Knottworks Construction, Inc.
PO Box 197
Otis, OR 97368
CCB #184887

Re: SPR 06SPR-23 2023.09.28 Incomplete Letter
Reed Road Site Plan Review application

In response to your Incomplete Letter referenced above, Knottworks Construction offers the following response / revision. Note, for ease of review, we indent and italicize our responses.

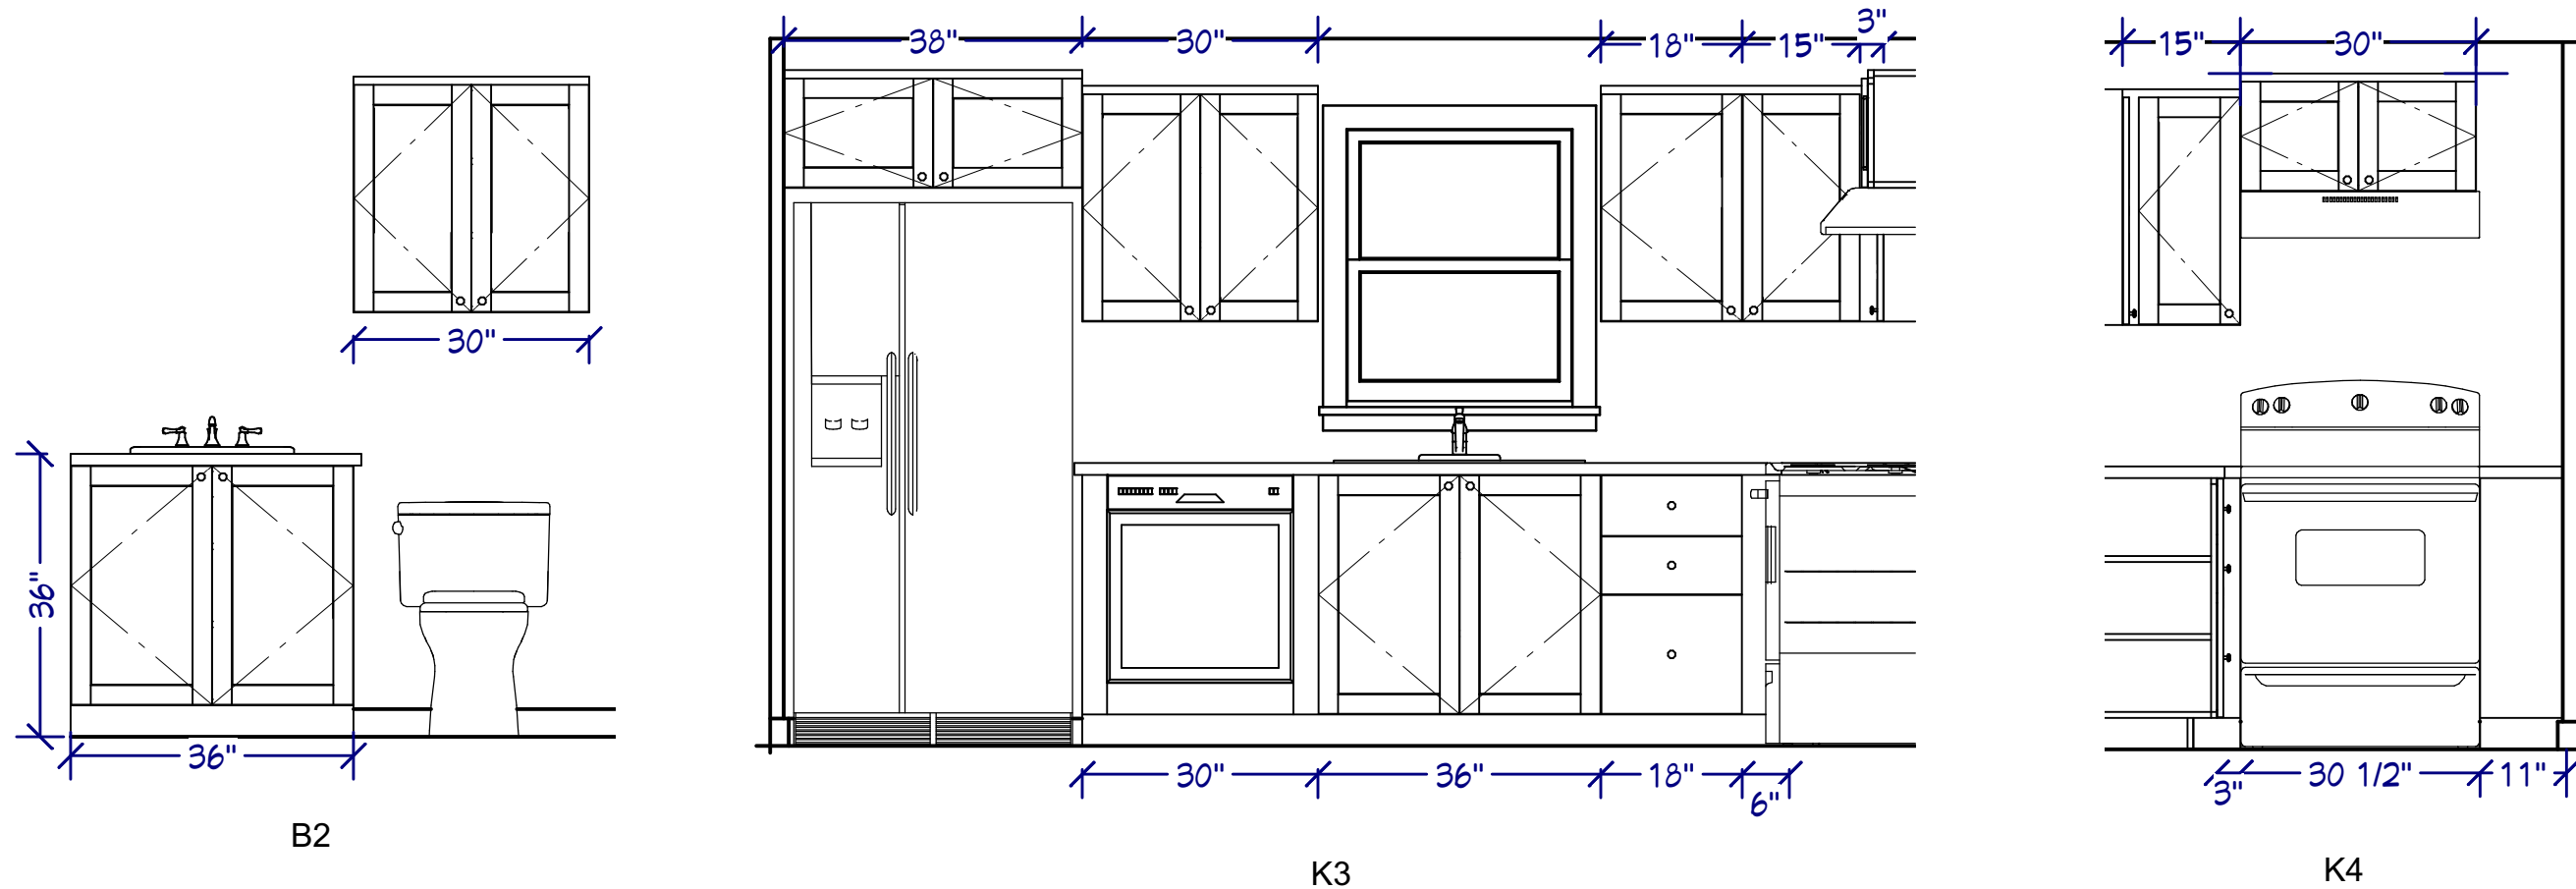
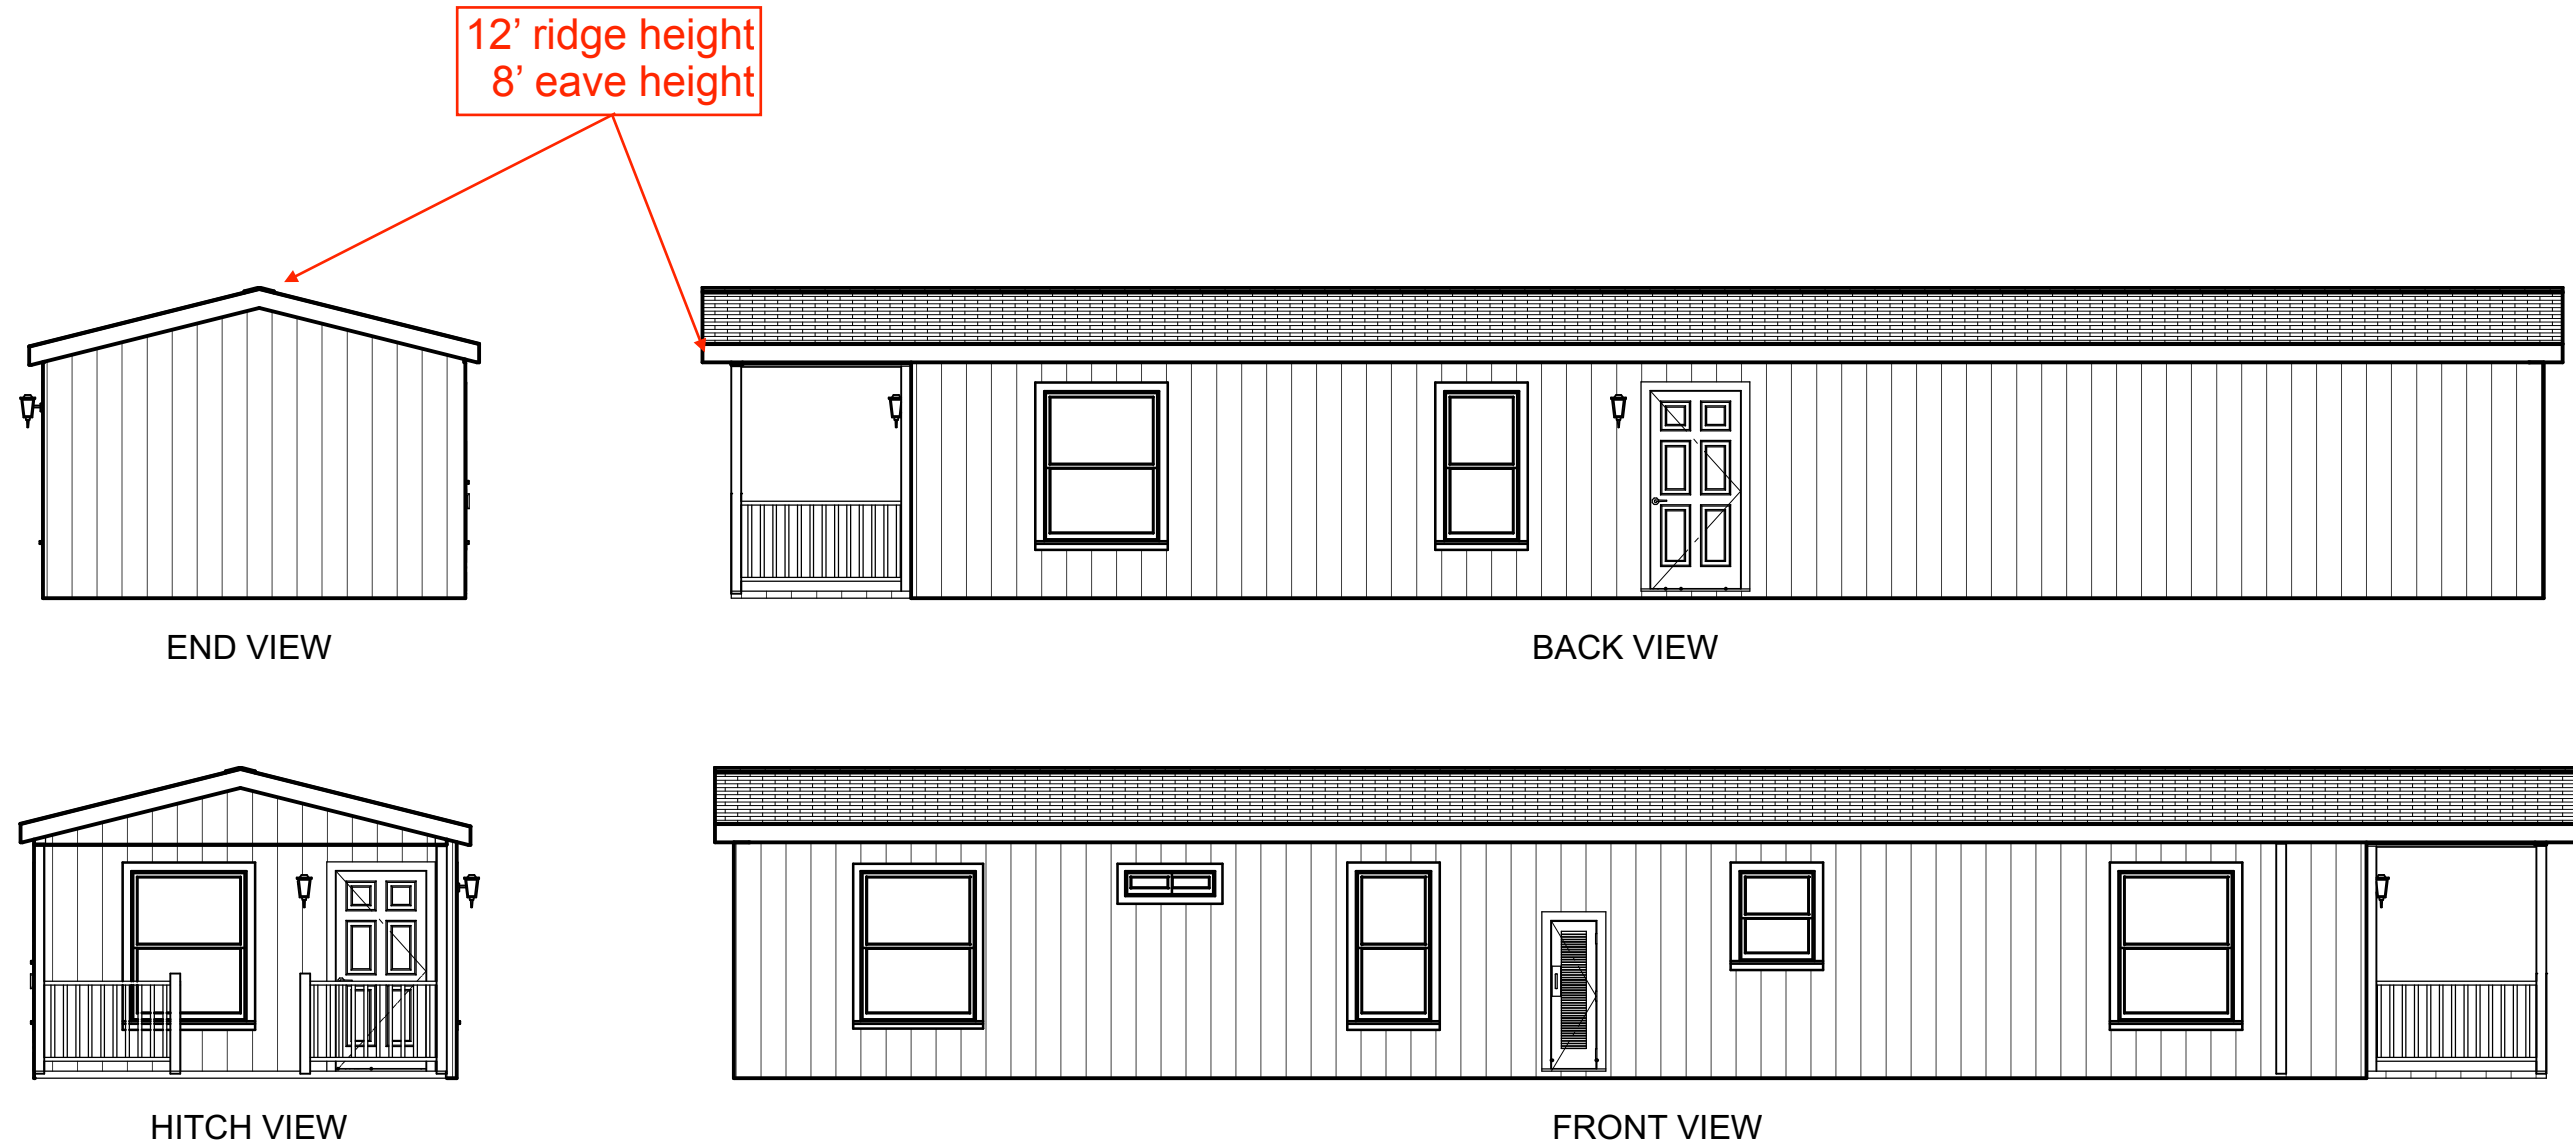
STAFF COMMENT: The applicant's burden of proof and submitted site plan did not include the required architectural drawing that meet the above criteria. Please submit these materials to staff.

Applicant Response: Please see attached manufactured home floor plans and elevations.
